From: Matthew Phillips
Sent: 24 May 2019 08:48
To: planning_admin
Subject: FW: P/2018/1045: RE: Ruabon: Drainage Strategy

Please add as Flood Officer comments

Sct184 Entrance:

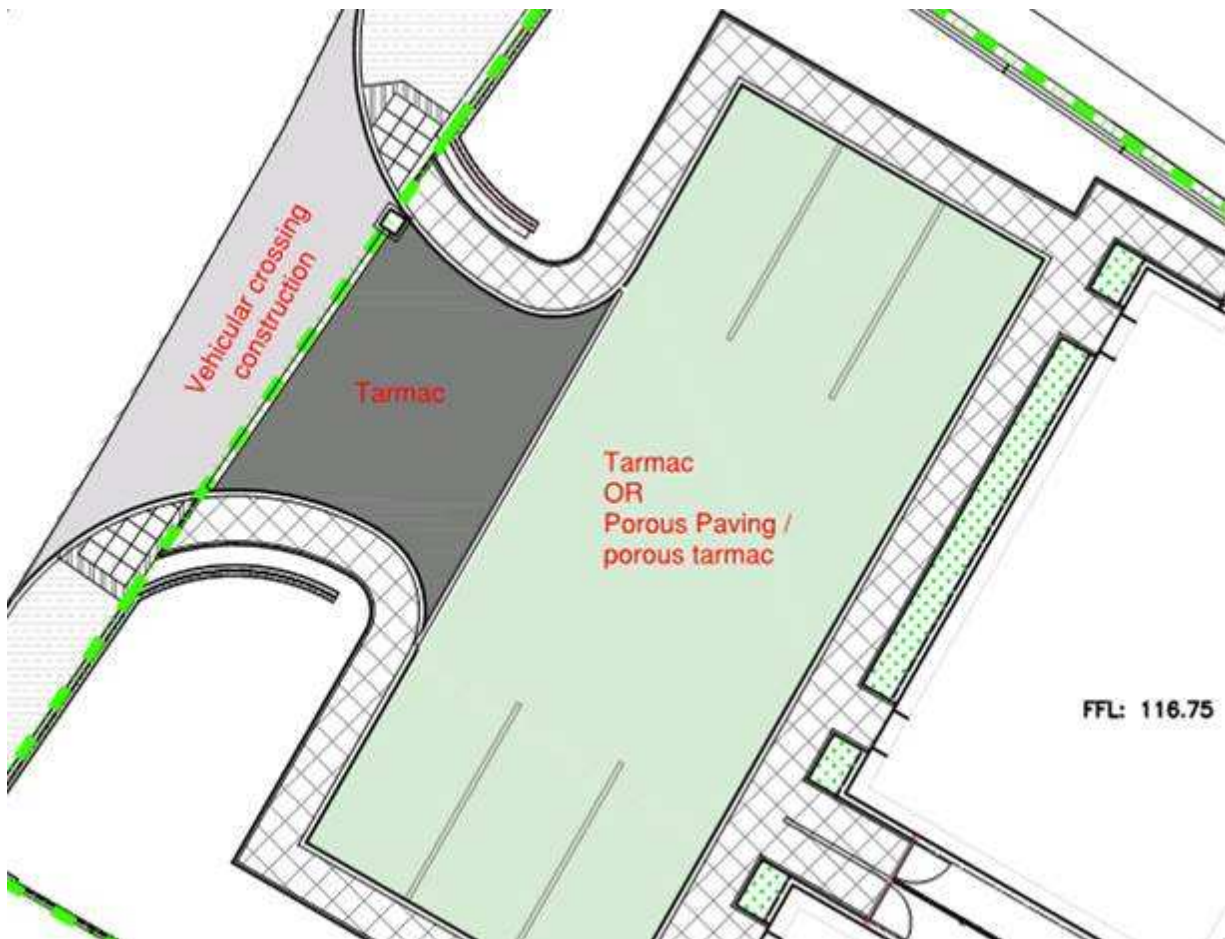
We have been liaising with Highways and have agreed the entrance works. We have some minor amendments to the drawings to do before submitting the formal application.

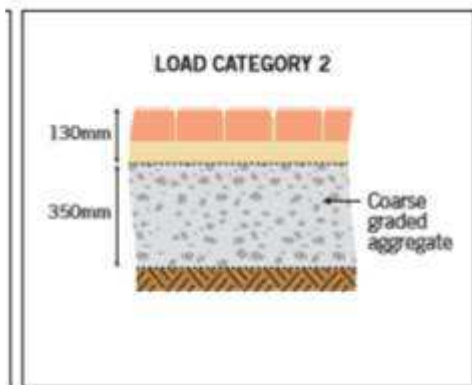
The front parking area has scope to either be tarmac with gullies/aco's OR permeable paving/tarmac. I envisage the access outwith the boundary to be tarmac with an aco across the junction with further impermeable tarmac used up to an edging kerb to delineate the parking area.

The soakaway could be either storm cells OR a trench soakaway OR a relatively thin layer of storage under the surface across whole parking area. Assuming porous paving used for the parking:

- The trench soakaway would be approx. 12x4x1.0m deep with 0.5m cover.
- The Cellular storage approx. 14x4x0.4m deep with 0.5m cover
- Precast perforated concrete rings = 4x1.8dia x 1.1m effective depth with 500mm above.
- The thin storage blanket approx. 0.3m thick under the permeable paving for the whole parking area = 137m²x0.25m however the load class would require 350mm thick anyway.

The above assumes that this would be constructed after the building construction and a CBR of 5% is achieved, otherwise we would have to introduce a hydraulically bound element.

If you choose an impervious surface for the parking area then the requirements would be as follows:

- The trench soakaway would be approx. 14x4x1.0m deep with 0.5m cover.
- The Cellular storage approx. 16x4x0.4m deep with 0.5m cover
- Precast perforated concrete rings = 4x2.1dia x 0.95m effective depth with 500mm above.

The choice of surfacing also affects the FFL with permeable paving having the ability to be laid to a flat profile rather than having to achieve minimum falls.
